Baseline Comment Bucket

Comment Bucket Buckets

Figure 33-8—PSE detection source

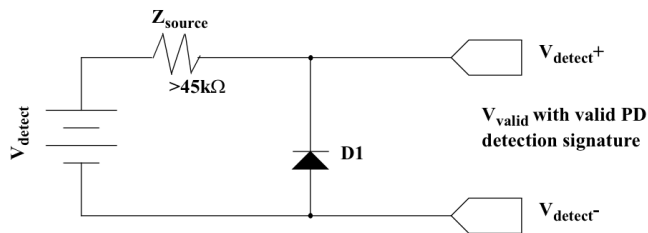
CI 33 SC 2.5 P 33 L 5 # 13
 LANDRY, MATTHEW SILICON LABS

A PSE performing detection should be able to provide two characteristics.

(1) Probing into a short circuit won't destroy the PSE or the source of the short.

(2) Two PSEs probing the same link segment should not result in a 25kohm differential impedance.

The probing voltage (V_{valid} and V_{oc}) and short circuit current limit defined in Table 33-2 accomplish (1). A simple shall statement can accomplish (2).

Instead we have some schematics (Figs 33-8 and 33-9) and a normative statement requiring conformance to them. This sure sounds like mandating an implementation -- and unnecessarily at that.

Strike Figs 33-8 and 33-9 or add a NOTE mentioning that they are informative only.

Strike Thevenin shall statement on line 45.

Add the following shall: A PSE shall present a non-valid signature as defined in Table 33-9 in all detection states.

Note that current PSEs conforming to the Thevenin circuits currently mandated will still satisfy this new shall.

- ◆ Not required for current limitation
- ◆ Does not force misdetects
- ◆ Does not force detects
- ◆ PICs testable?
- ◆ Suggested remedy “shall” statement may also be difficult to test
- ◆ Eagerly await suggested text
